Conceptual Review Agenda

Schedule for 03/10/14 to 03/10/14

Re: 412 Vine Dr - Office/lab

Description of project: This is a request to construct two buildings for office/laboratory use at 412 East Vine Drive (Parcel #s 97013-00-062, 97122-00-008, 97013-08-001, 97013-06-001 & 97013-06-002). The existing structures on site would be removed and two, 3-story buildings constructed in their place. Each building would be approximately 30,000 to 40,000 square feet. The site is located in the Community Commercial - North College (C-C-N) Zone District. Office/laboratory uses are subject to Administrative (Type 1) review.

CONCEPT PLAN

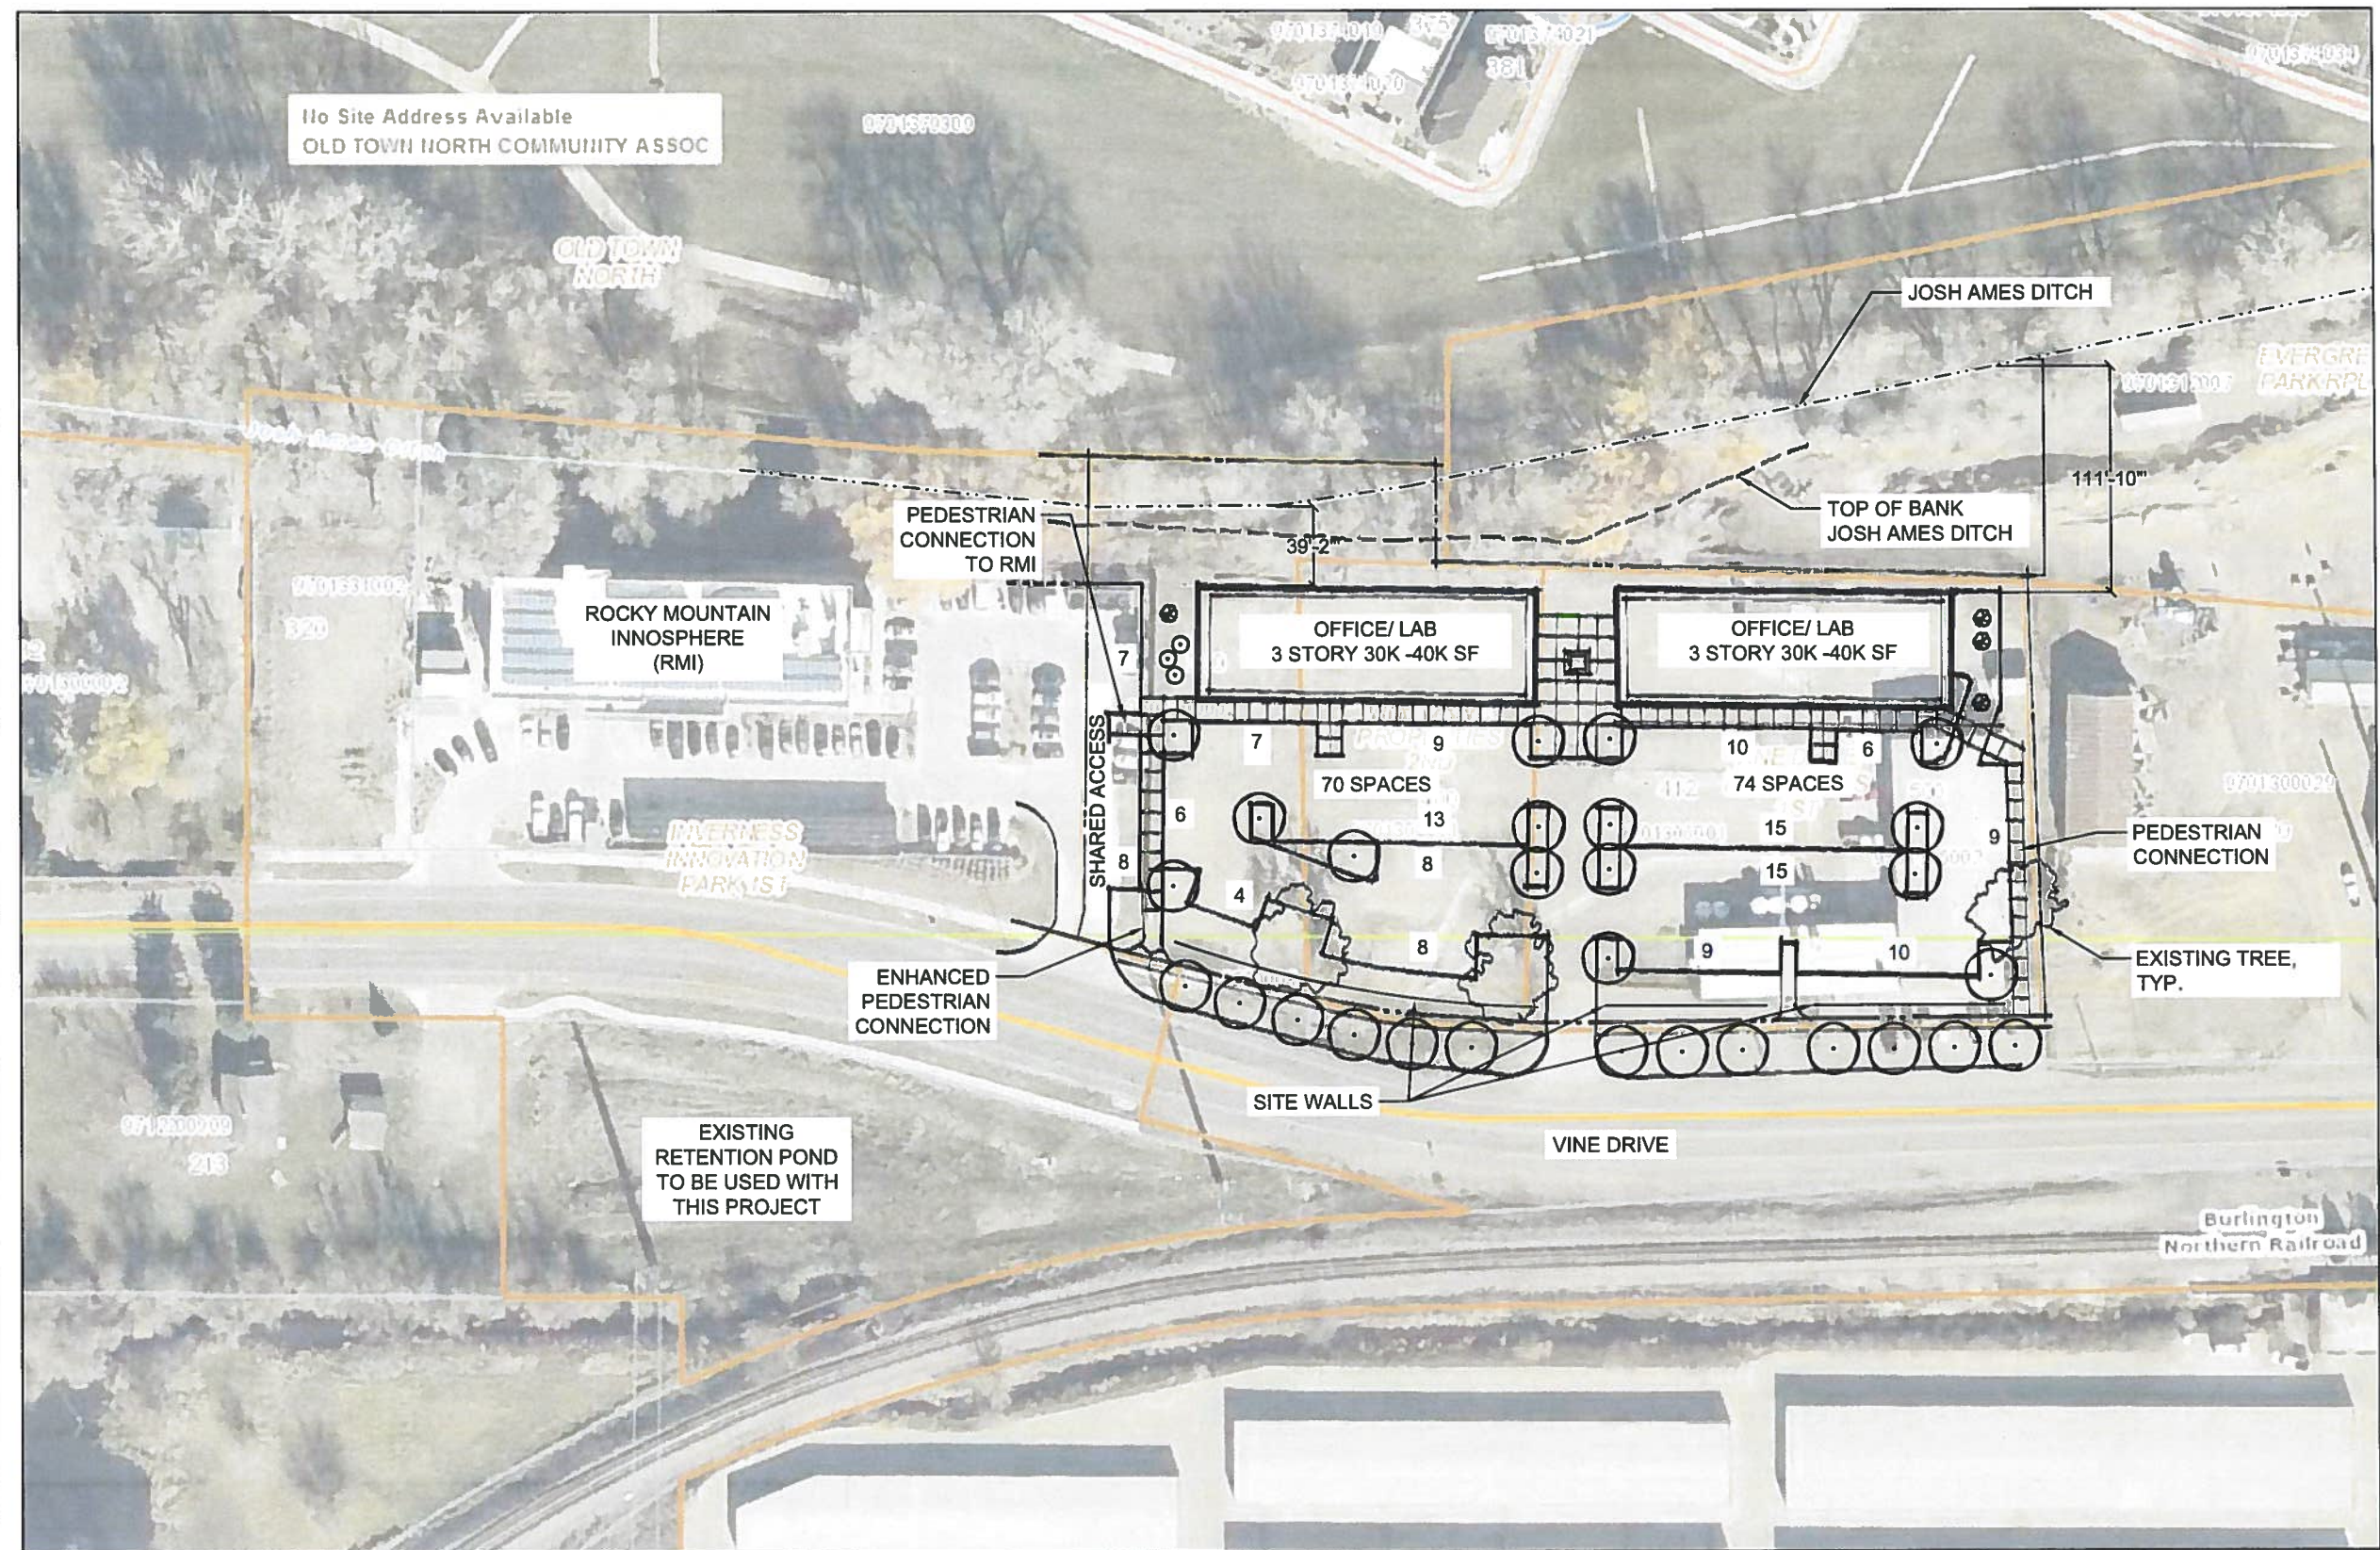
1. A modification to LUC 3.5.3(C)(2) which establishes build to lines in relationship to the street is required unless it's determined that one or more of the exceptions in 3.5.3(C)(2)(d) is satisfied.
2. 144 vehicle parking spaces are proposed which is less than the maximum 3 spaces per 1000 square feet allowed based on the buildings' proposed square footage. Parking for the existing RMI site is insufficient to meet their parking demand. Is there any possibility of increasing the amount of parking proposed? A min. of 5 HC spaces are required with one meeting LUC 3.2.2(K)(5)(d) for van accessible space.
3. A min. of 1 bicycle storage or space is required for every 4000 s.f. of (office) building square feet with 20% of the storage/spaces being enclosed and 80% fixed (racks) or not enclosed. LUC 3.2.2(C)(4).

2. Adding to comments from Zoning: A key Code standard requires mixed use buildings to be placed to face onto street sidewalks with no intervening parking lots. This is perhaps the most important site planning standard in the Code. It implements important and pervasive aspects of the community's Comprehensive Plan. Purposes are to create attractive and active streets that encourage pedestrian use. The proposed plan is fundamentally contrary to this standard. A Modification of the standards could be requested based on the proposed plan meeting the purposes as well as or better than a plan that complies with the standard, and/or the proposed plan being necessary due to unusual physical conditions unique to the property.

3. In order to proceed forward with consideration of a Modification, please prepare a plan that complies with the standard, in similar format to the plan with the layout as submitted, for comparison and evaluation side-by-side. The point is to aid review of the Modification if the applicants choose to proceed with a layout similar to the one submitted.

4. Some factors to incorporate into a plan requiring the Modification request would be: 1) bring architectural features of the building out to the street sidewalk; and 2) bring enhanced tree-lined walkways out to the street sidewalk. The Siberian Elm trees do not warrant the Modification as they are poor to fair. If they can be kept and incorporated into plans they would be a positive aspect of the development but they should not determine building placement as shown in the application.

5. A question to be addressed: can the assertion about vibration from the railroad and Vine Drive be quantified or validated, in order to be useful as a potential consideration for a decision maker? i.e., how much vibration occurs; what kind of lab uses would be precluded? Lab-type uses do not appear to be incompatible with the presence of railroads as a general land use principle, based on light industrial areas where such uses often occur near rail lines.

1
A1.1
GRADE LEVEL / SITE PLAN
SCALE : 1" = 20'-0"

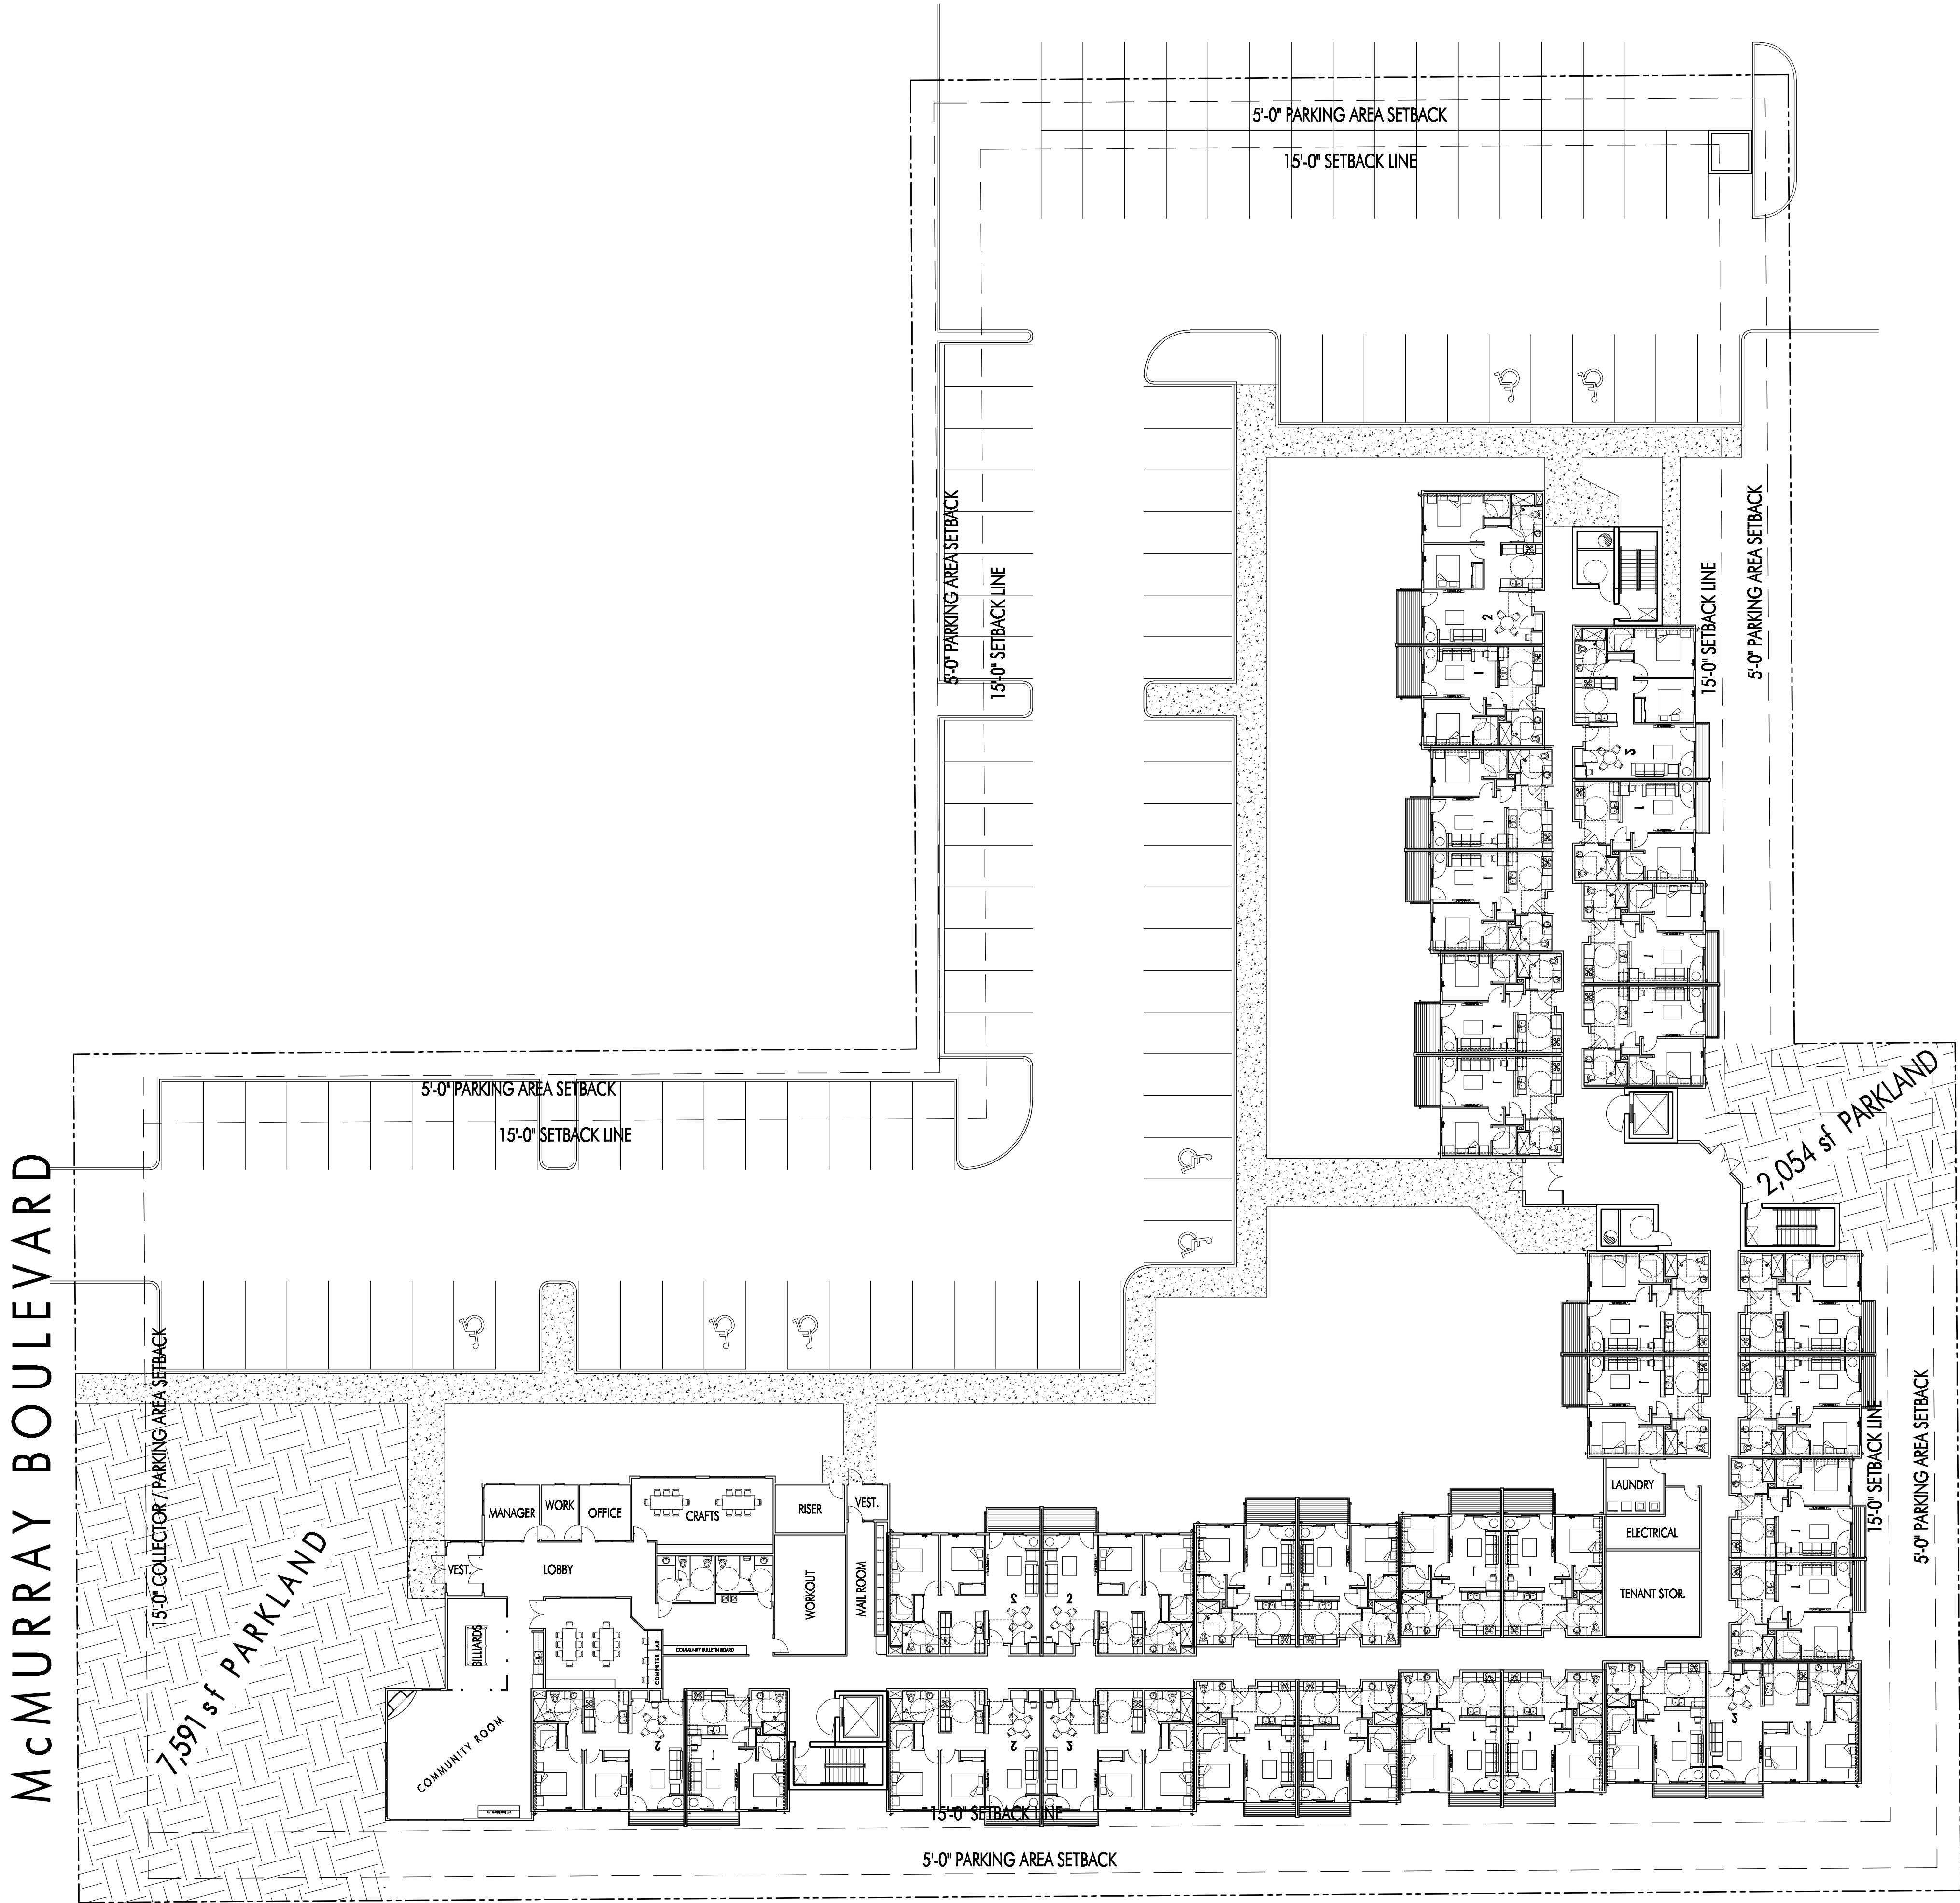
1. Platting of the property is required.
2. The maximum number of stories allowed for residential uses in the HC zone is 3. The application indicates that at least 2 modifications will be necessary. Is this one of them? Also, since the building is taller than 40', the Building Height Review process in Sec. 3.5.1(G) will apply.

3. The parking lot design and landscaping will need to comply with Sec. 3.2.1 and 3.2.2 of the LUC. A minimum of 200 parking spaces are required based on the number of one- and two-bedroom units, but only 99 are proposed. Is this another modification?

4. Site plan proposes only one trash enclosure. That seems insufficient. Please refer to LUC 3.2.5 for trash enclosure requirements.
5. As a multi-family development and 160 bedrooms a minimum of 160 bicycle storage/spaces required with 96 of these enclosed and 64 fixed to outdoor racks. Please refer to LUC 3.2.2(C)(4).

2. The maximum height for residential buildings in the Harmony Corridor is 3-stories. The 4 stories as proposed will require approval of a modification of standard.
